**Notice of Allowability**

10/660,894

### EXAMINER'S AMENDMENT

FIG. 1

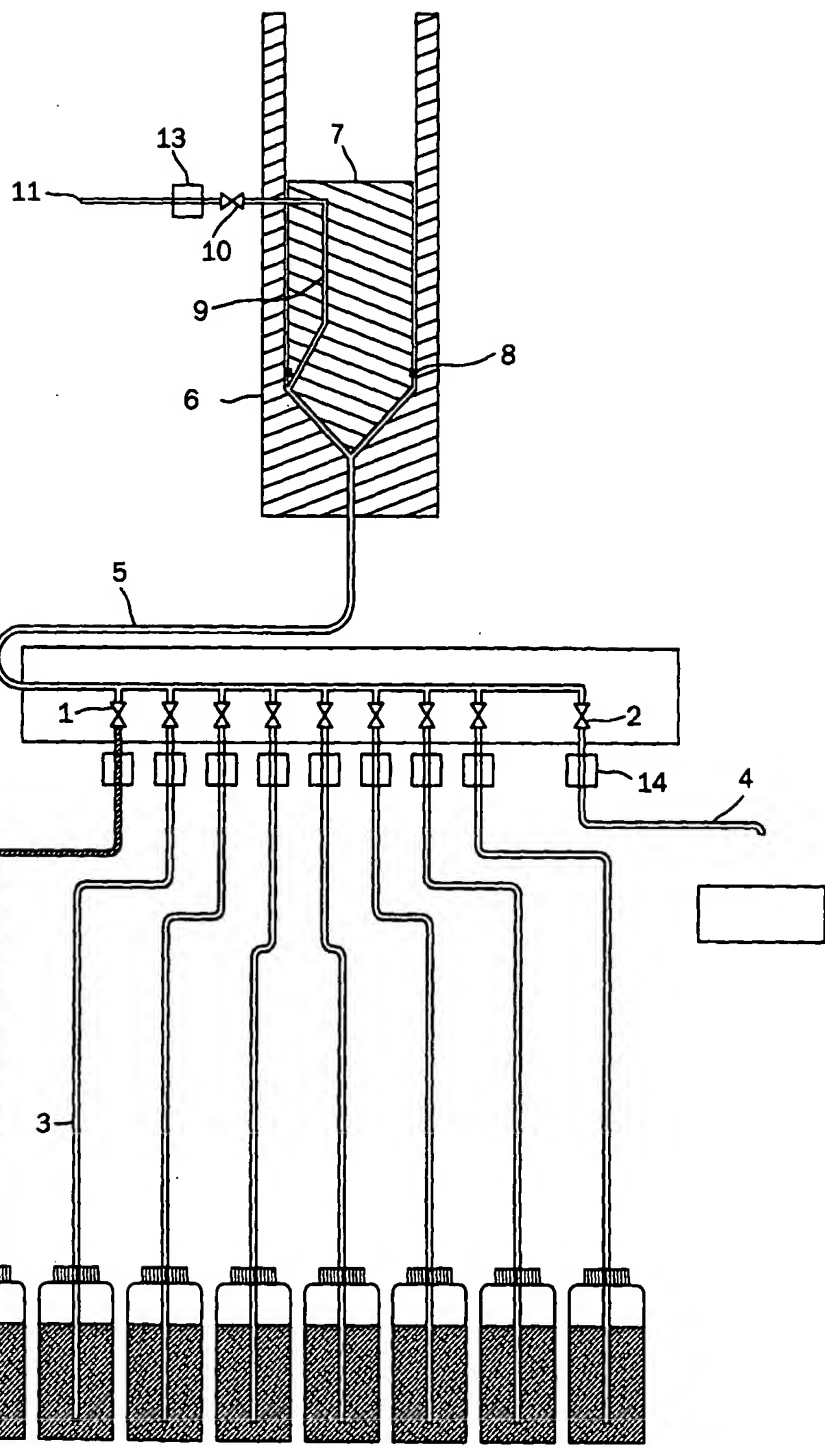
The following changes to the drawings have been approved by the examiner and agreed upon by applicant: in Figure 1, "containers" have been labeled as --15--, as per the attached drawing. In order to avoid abandonment of the application, applicant must make these above agreed upon drawing changes.
